ACRS CLINCH RIVER BREEDER REACTOR (CRBR) SUBCOMMITTEE MEETING
MEETING MINUTES
JUNE 1, 1982
WASHINGTON, DC

The purpose of the meeting was to discuss the seismicity and seismic design for the CRBR.

BASIC SEISMIC TEST PROCEDURE

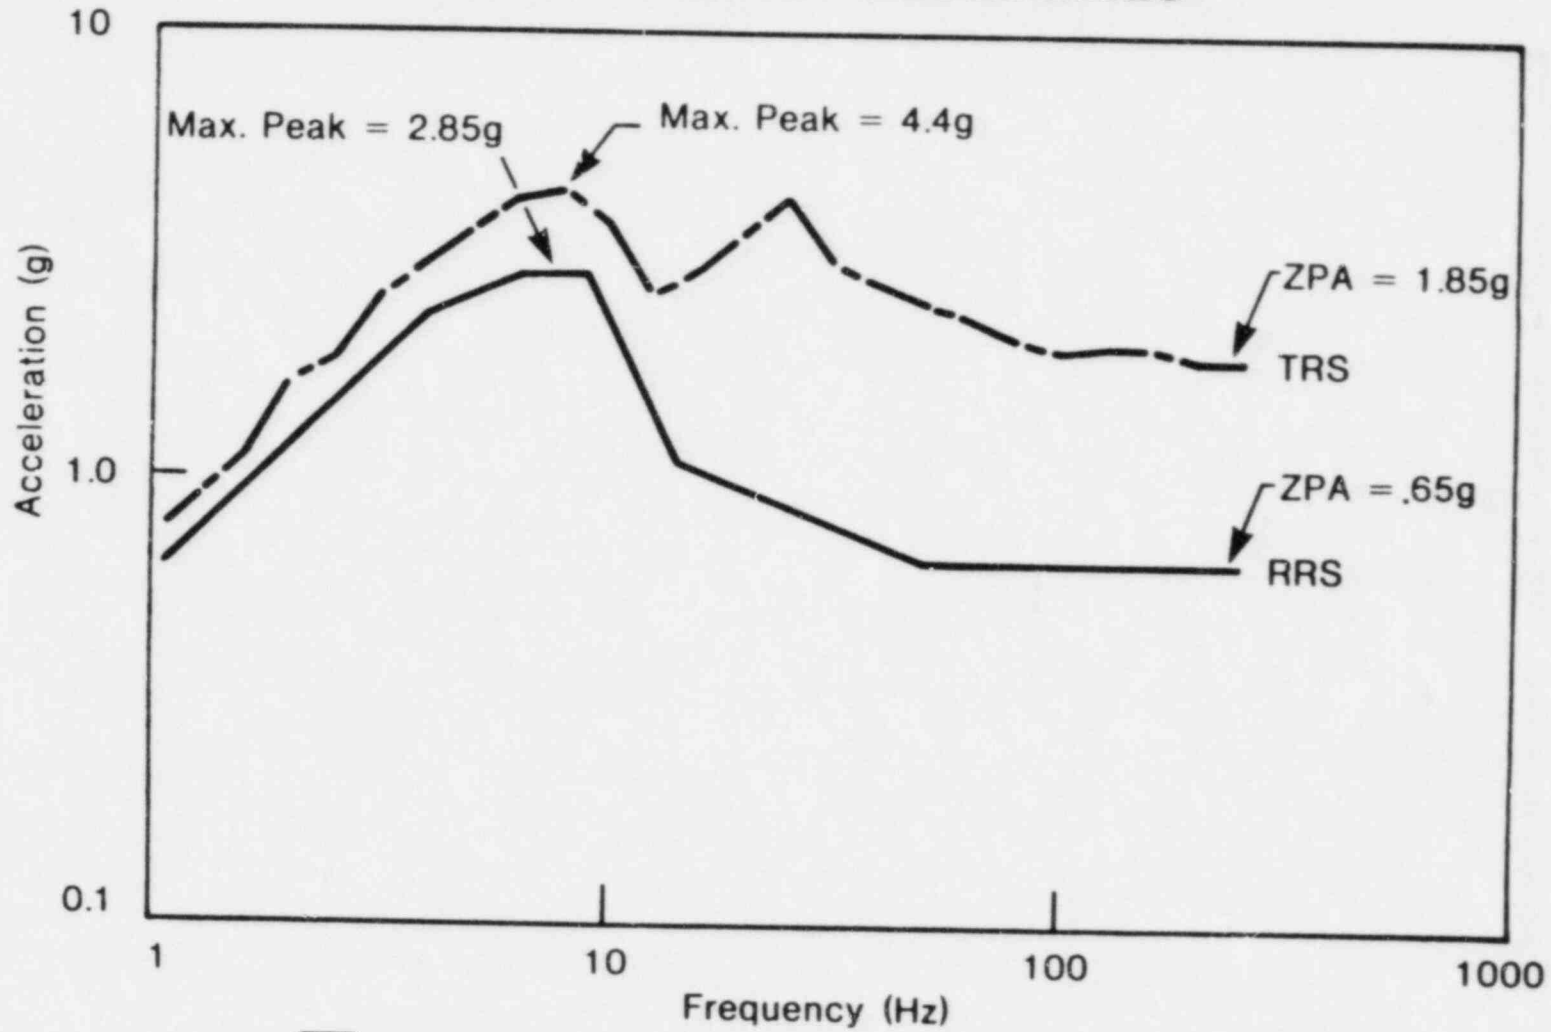
The methodology applied in the seismic testing of Class IE components was also detailed. W uses the sine beat test procedure (Figure 4). Drs. Trifunac and Zudans noted that the upper resonance test frequency search is limited to 33 Hz. Mr. Morrone noted the equipment excited at frequencies above 33 Hz will see little acceleration compared with the design values. He also said that the test response spectra accelerations always envelope the required response spectra (Figures 5-6).
